Inspection Photos

API: 061-06838

Operator: INVESTMENT EQUIPMENT LLC

Inspection Date: 10/3/2024

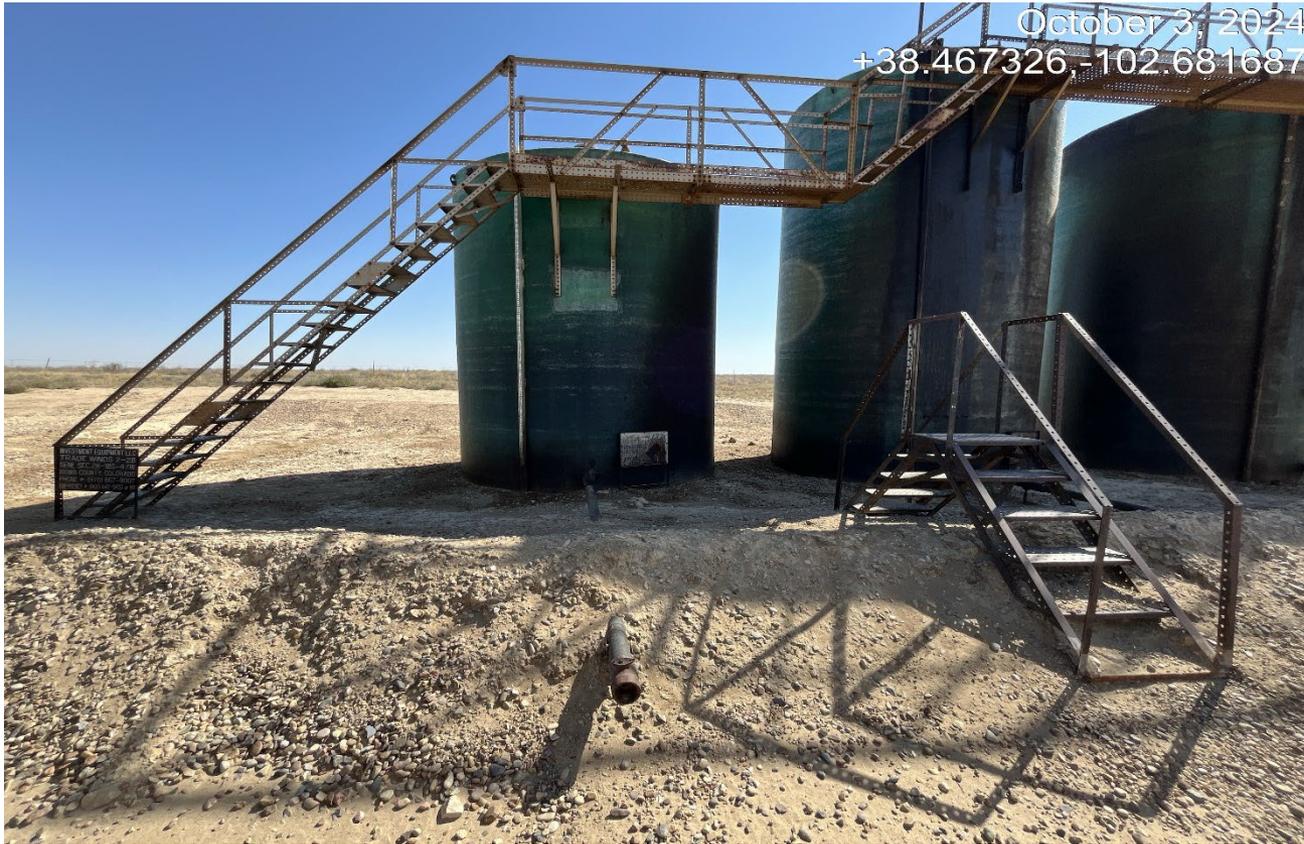
Photo 2. Facing toward the tank battery. The H₂S wind sock is missing. There is oily stained soils that extend the entire area of the containment from a previous spill that was never cleaned up. Previous CA's were not completed.
